## Technical change to RSM modules

PCN-number: 20210506

DEKAFIX detail

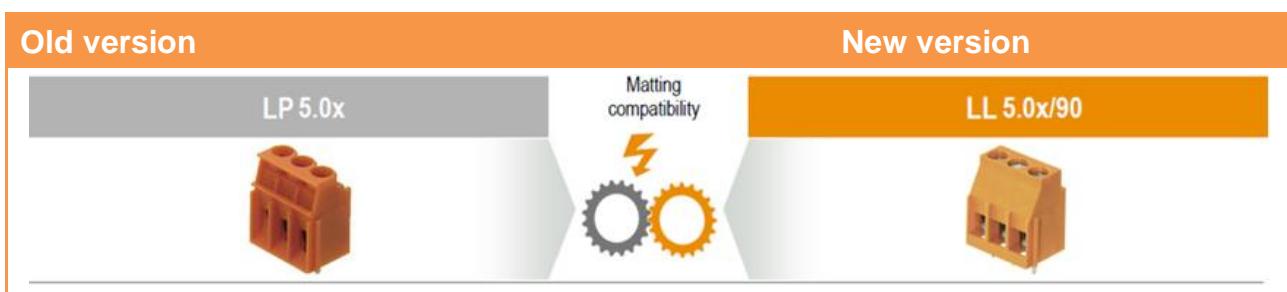
Articles on Section 5 were provided in the past with LP connectors. Furthermore, they were delivered with Dekafix.

Dekafix is the universal marker for terminals, plug-in connectors and electronic modules from the Weidmüller product range. It lies flush in the marker channel in the form of a card. (see detail)

Affected parts are similar to illustration (8 or 16 Relays)

Based on continuous improvement the LP connectors with Dekafix will be replaced by LL with pad printing technology.

Furthermore, to fulfill with UL approvals, product label has been changed to include the UL logo with its file number (c<sup>UL</sup>us) and the appropriate UL rated values.
